Access Compliance Report

Public Rights-of-Way

Intersection ID: 24279	Main Street: EDENBRIDGE_LN	Cross Street: WINDYRUSH_RD	Location: E
ADA ID: BCA0A5ABC3B8	Ramp Type: PerpDiag	Initial Pass/Fail: Fail	Overall Compliance: No
			Severity Score: 21.25

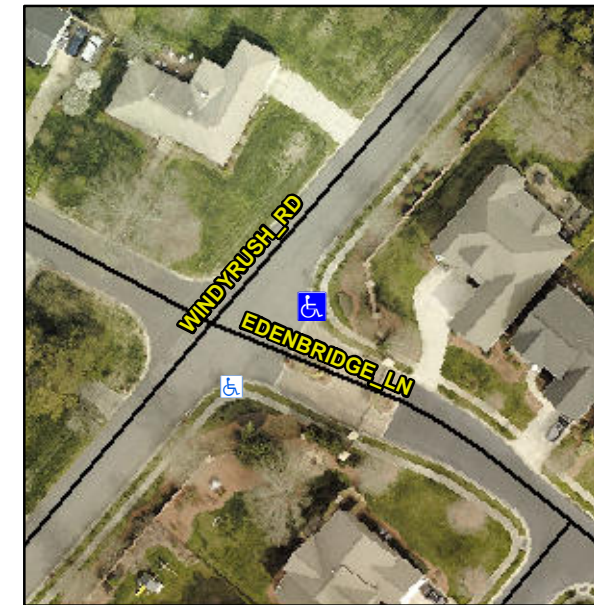
Not Found, R304.5.1, R304.2.2

Compliance	Description	Data	Compliance	Description	Data
N/A	Ramp Length (in)	47.0	No	Ramp Slope (%)	10.2
No	Ramp Width (in)	41.5	Yes	Ramp XSlope (%)	1.9
N/A	Flare Type LT	N/A	N/A	Flare Type RT	N/A
N/A	Flare Slope LT (%)	N/A	N/A	Flare Slope RT (%)	N/A
N/A	Flare Traversable LT?	N/A	N/A	Flare Traversable RT?	N/A
N/A	Landing Length (in)	N/A	N/A	DWS Provided?	N/A
N/A	Landing Width (in)	N/A	N/A	DWS Contrast?	N/A
N/A	Landing Slope (%)	N/A	N/A	DWS Length (in)	N/A
N/A	Landing X Slope (%)	N/A	N/A	DWS Full Width?	N/A
N/A	Landing Curb? (Y/N)	N/A	N/A	DWS Offset (in)	N/A
N/A	Shared Landing?	N/A			
N/A	Gutter Ponding?	N/A	N/A	Gutter Slope (%)	N/A
N/A	Gutter Lip Ht (in)	N/A	N/A	Gutter X Slope (%)	N/A
N/A	Painted X Walk1?	No	N/A	Painted X Walk2?	No
	X Walk 1 Direction	To NW		X Walk 2 Direction	To SW
N/A	X Walk 1 Width (in)	N/A	N/A	X Walk 2 Width (in)	N/A
	X Walk 1 Slope (%)	3.4		X Walk 2 Slope (%)	0.2
	X Walk 1 X Slope (%)	2.5		X Walk 2 X Slope (%)	3.1

Remove & Replace Curb Ramp With Two New Directional Ramps or Equivalent.
